SERVICE LETTER

No. 541

Subject: Fuselage Nose Cone Drain Holes

Models Affected: PA-30 Twin Comanche

FUSELAGE NOSE CONE

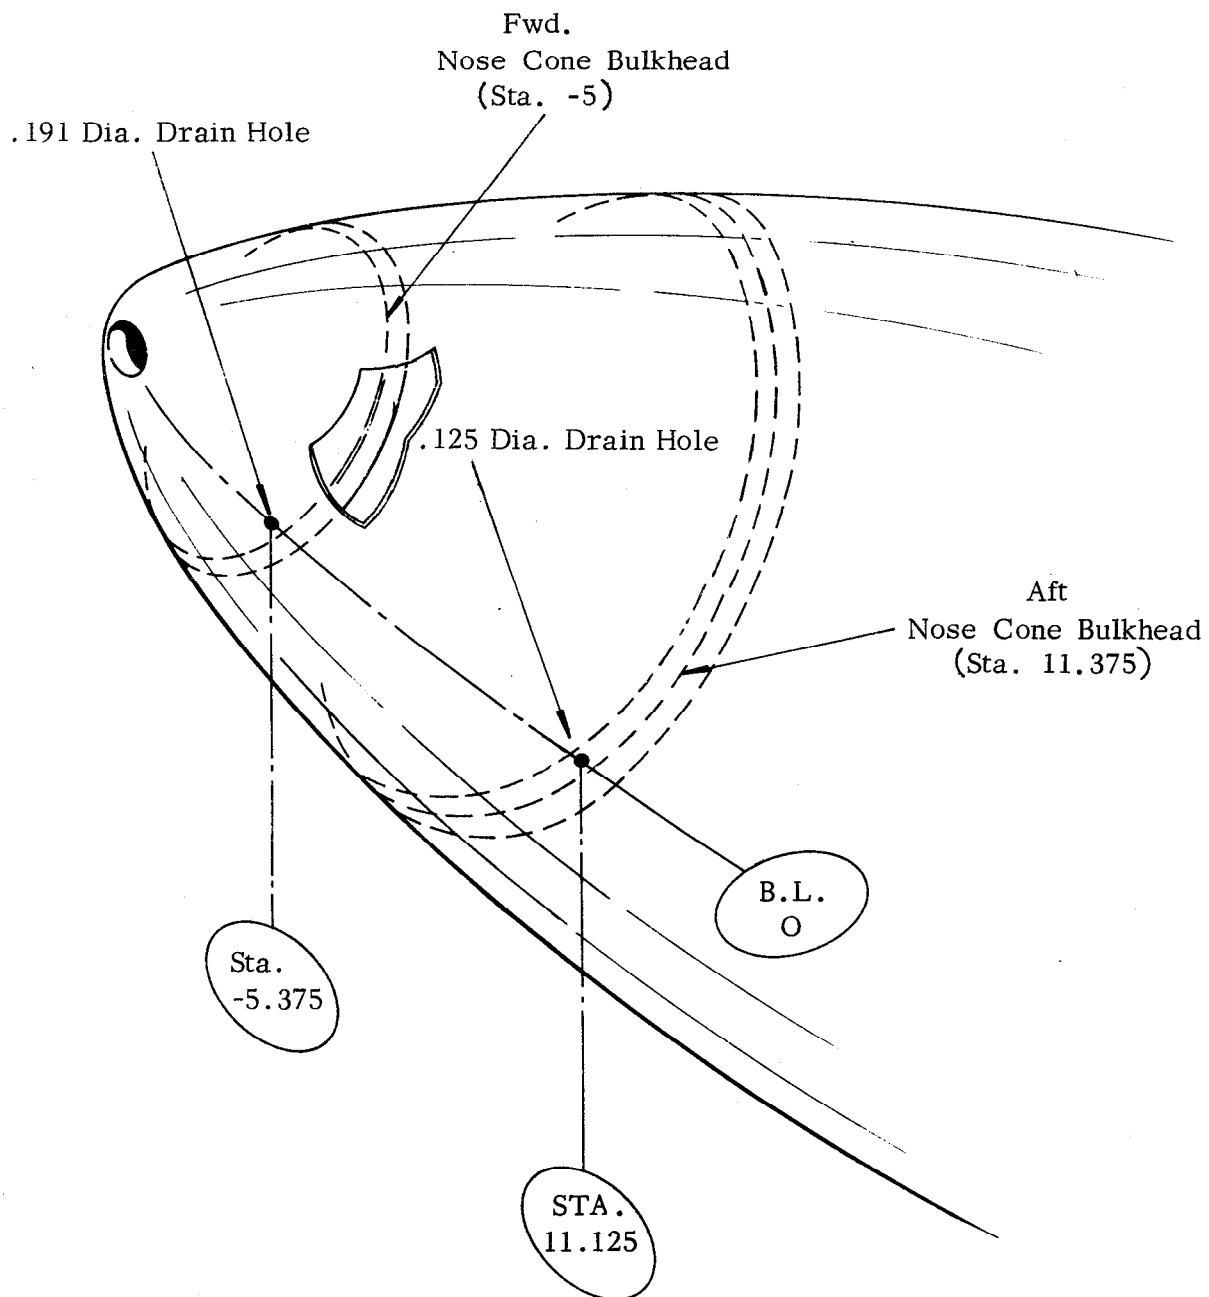
Purpose: To inspect the fuselage nose cone section of the above referenced aircraft to ascertain that drain holes are present in the fuselage nose cone, as indicated by the sketch on the reverse side of this letter.

Instructions: If the above referenced inspection reveals that drain holes do not exist at stations 11.125 and -5.375, add drain hole(s) per sketch on reverse side of this letter.
